TECHNICAL BULLETIN No. 021-2008**11-11-2008****Model: RSV 1000 My 06 – Tuono My 07****Subject: New clutch spring washers**

**New version - code AP0627535****Old version - code AP0627530**

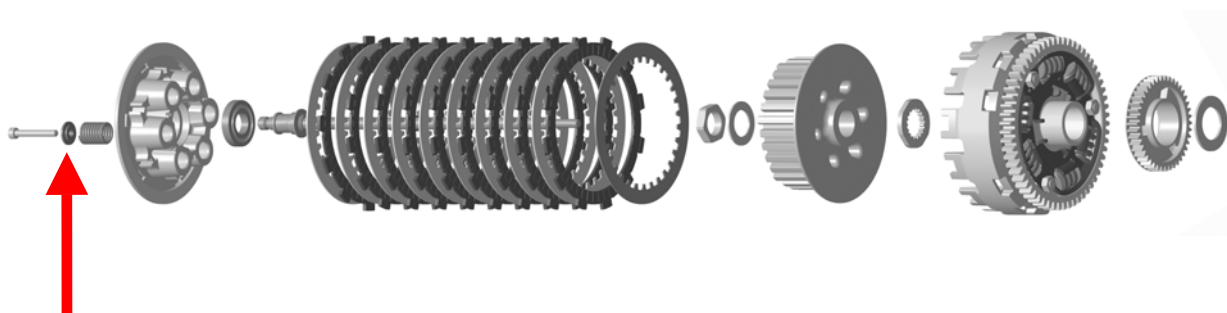
from engine No. **8176297** on, new clutch spring washers have been introduced in models specified above in order to reduce the effort necessary to disengage the clutch.

The new washers can be identified by increased thickness and the presence of a groove.

WARNING: the new clutch spring washers are installed only with clutch discs code AP0659800, fitted to RSV as from the 2006 model and to Tuono as from the 2007 model. In order to identify with certainty the codes to be used, refer to the following table.
